Gesellschaft für Schwerionenforschung mbH
Planckstrasse 1
D-64291 Darmstadt
GERMANY
www.gsi.de

Design: K:\GSIJOB\COME_AND_KISS\DIRICH\DIRICH1\DIRICH1.DSN	
Modified: Tuesday, March 15, 2016	Size: A3 Page: 1 / 8
Designer: <Designer>	Layouter: <Layouter>

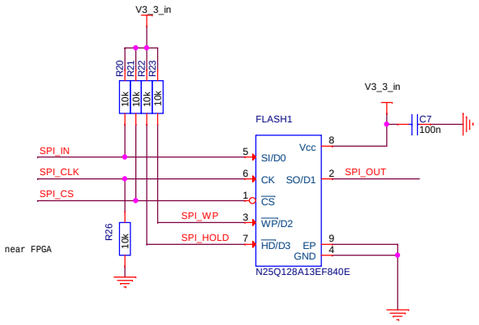
Place JTAG connector close to the edge

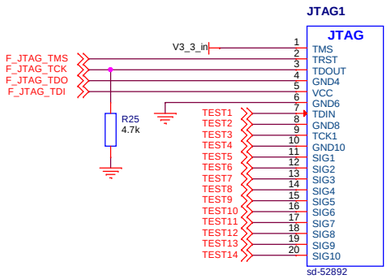
@PETER:
Bitte korrektes Symbol einfügen.

in the final system, light should be off...
So, maybe we remove this LED again...

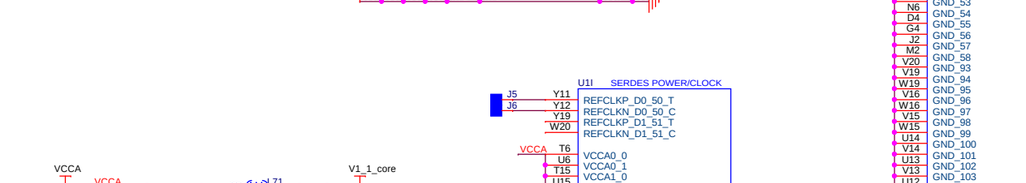
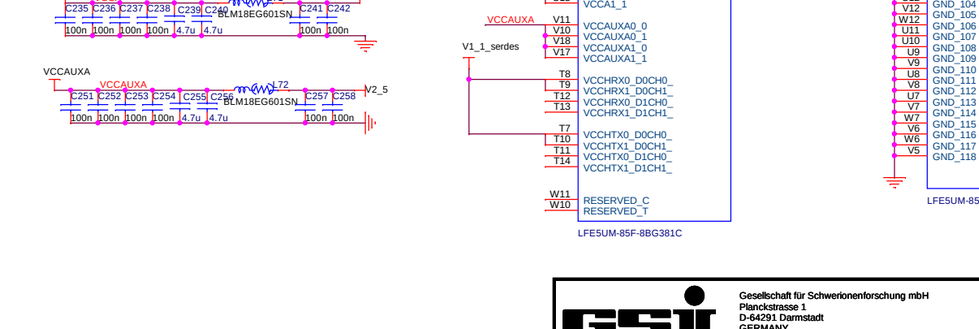
@PETER
die 47nF 0201 sollten durch
33nF 0201 getauscht werden...
GRM033B10J333KE01#
würde es tun.
